## Washer Fluid Reservoir Rattles While Driving on Rough Roads

This Service Information Bulletin (Revision 4) replaces SI B61 06 15 **dated April 2021**.

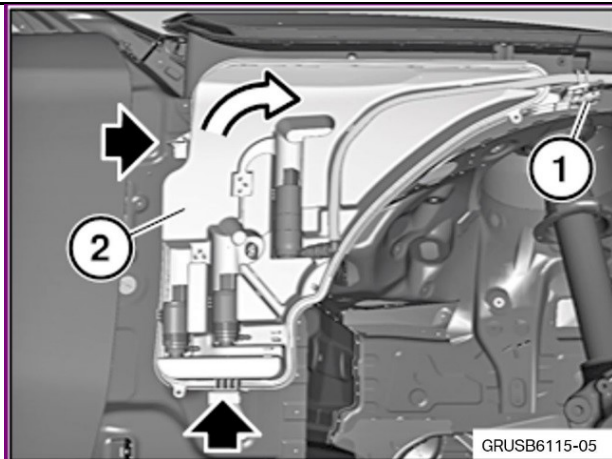
Rattling noises heard from vicinity of glove box.

The windshield washer reservoir upper plastic locating guide tab has too much lateral play.

Apply a piece of self-adhesive felt tape to the upper plastic locating guide of the washer fluid reservoir.
